Project	IEEE 802.16 Broadband Wireless Access Working Group < http://ieee802.org/16 >	
Title	Preamble, FCH and MAPs Transmission in Transparent Relay Station	
Date Submitted	2007-03-13	
Source(s)	<p>Young-jae Kim, Kyu Ha Lee, Jae Hyung Eom, Changkyoon Kim Samsung Thales San 14, Nongseo-Dong, Giheung-Gu, Yongin, Gyeonggi-Do, Korea 449-712</p> <p>Byung-Jae Kwak, Su Chang Chae, Young-il Kim ETRI 161, Gajeong-Dong, Yuseong-Gu, Daejeon, Korea 205-350</p> <p>Aik Chindapol Siemens Corporate Research 755 College Road East Princeton, NJ, USA</p> <p>Yousuf Saifullah Nokia 6000 Connection Drive, Irving, TX</p>	<p>Voice: +82-31-280-9975 Fax: +82-31-280-1562 youngjae2.kim@samsung.com kyuha.lee@samsung.com</p> <p>Voice: +82-42-860-6618 Fax: +82-42-861-1966 bjkwak@etri.re.kr</p> <p>Voice: +1 609 734 3364 Fax: +1 609 734 6565 aik.chindapol@siemens.com</p> <p>Voice: +1 972 894 5000 Yousuf.Saifullah@nokia.com,</p>

Preamble, FCH and MAPs Transmission in Transparent Relay Station

Figure 1. Example of a preamble, FCH, and MAPs transmission in transparent RS

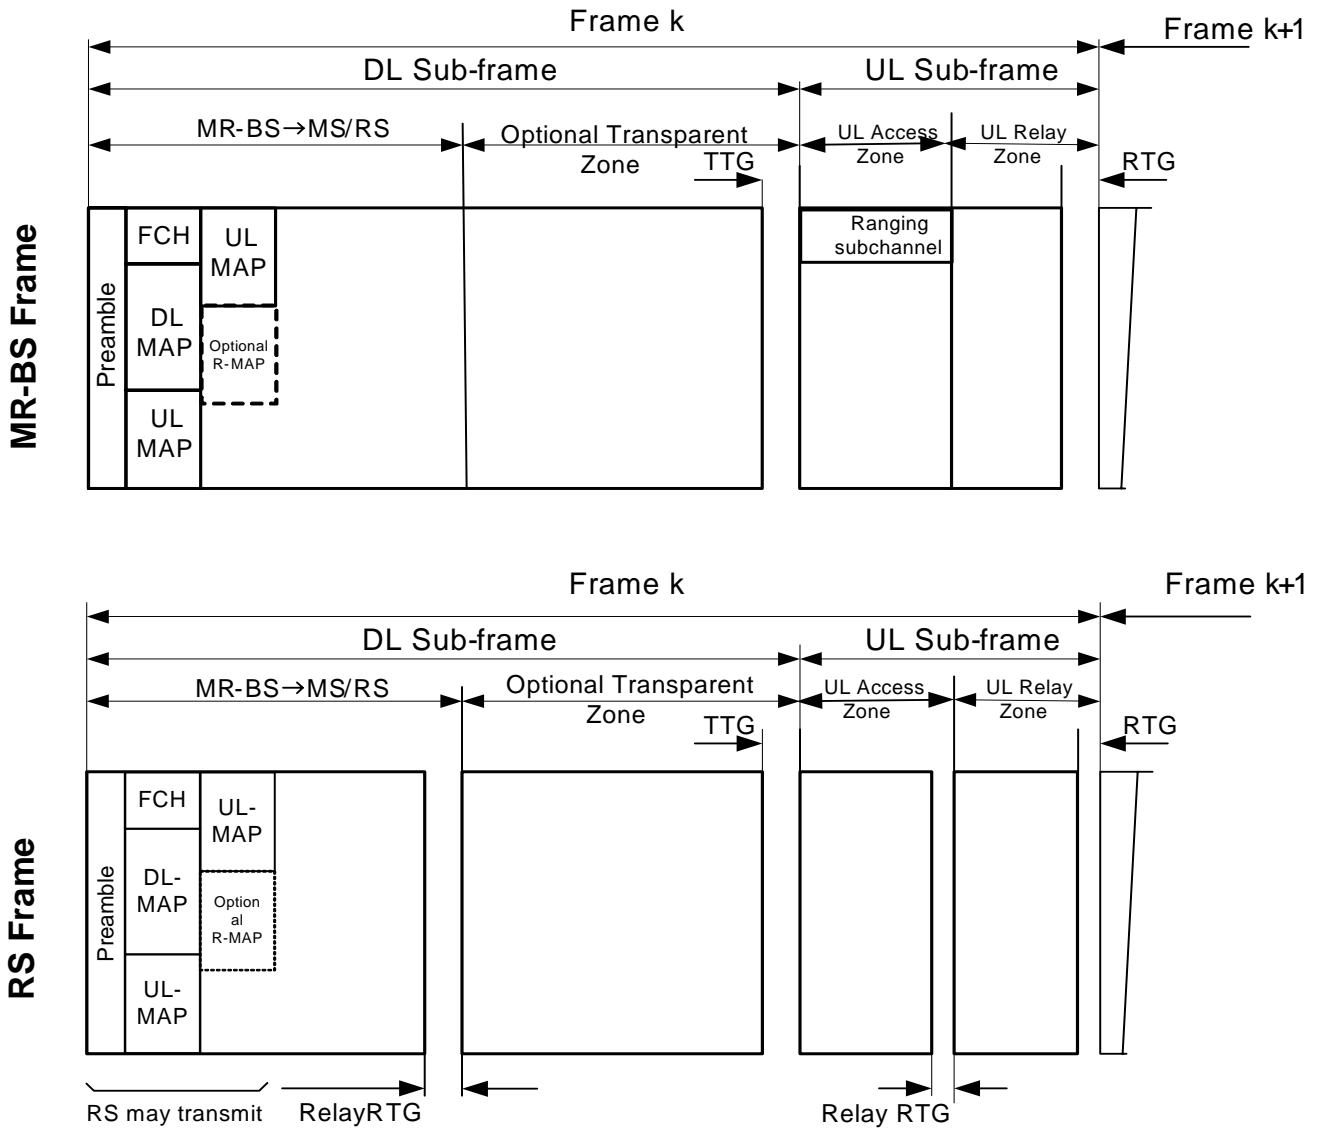
This proposal suggests that a transparent RS may transmit a preamble, FCH and MAPs that are same with those of MR-BS.

Figure xxx. Example of configuration for a transparent relay frame structure

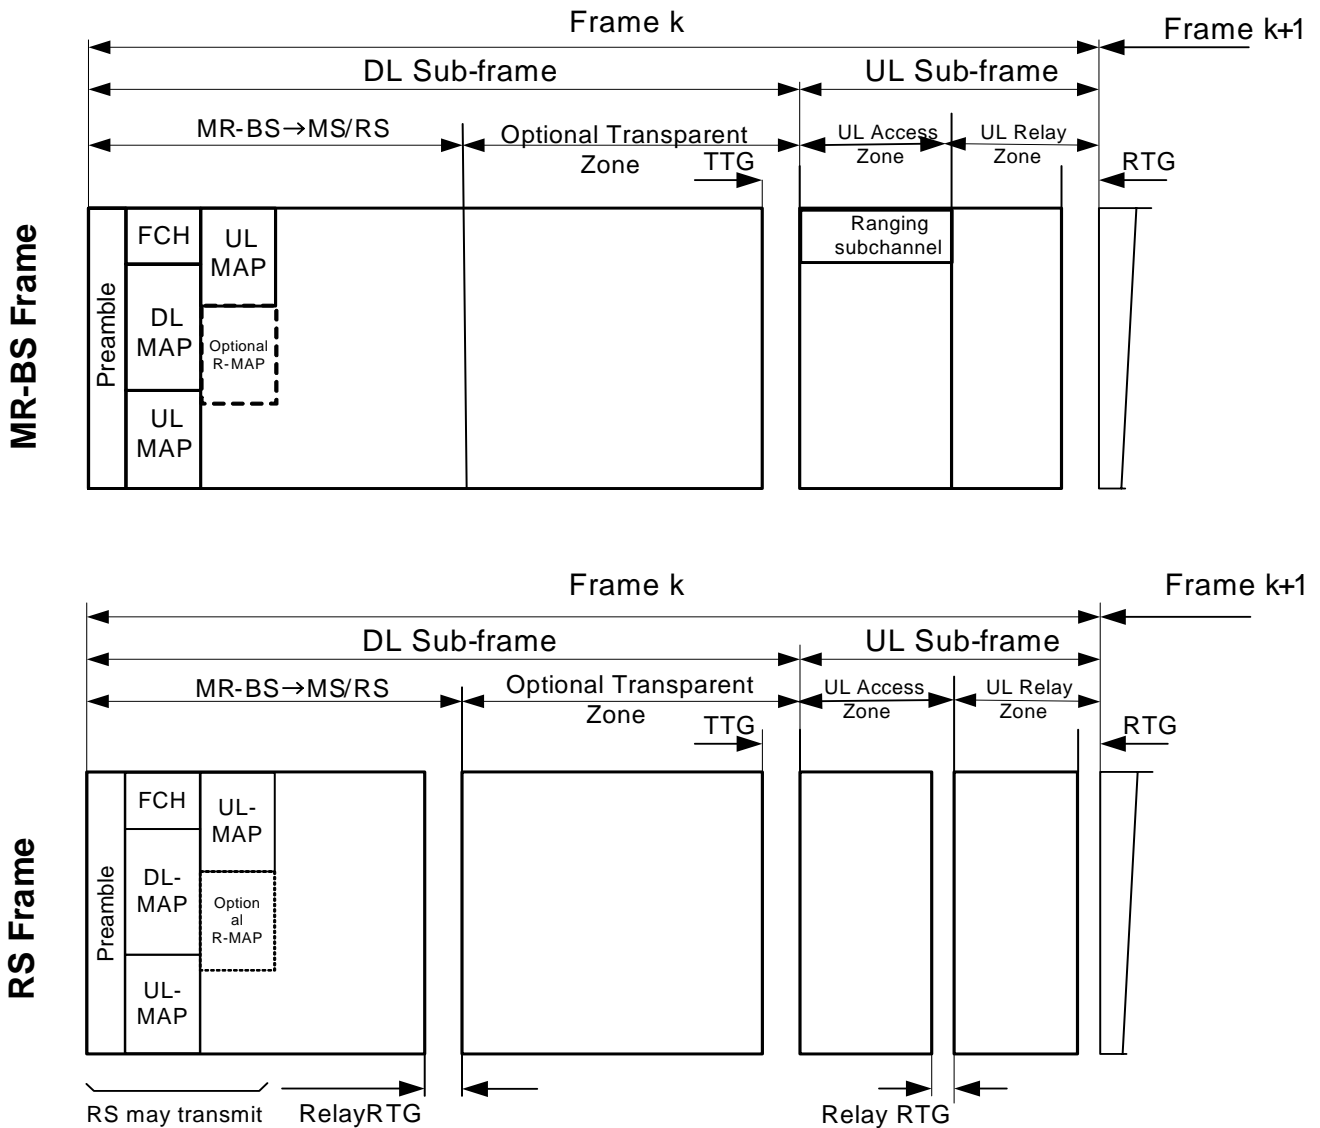
[Replace Figure xxx at section 8.4.4.7.1.1]
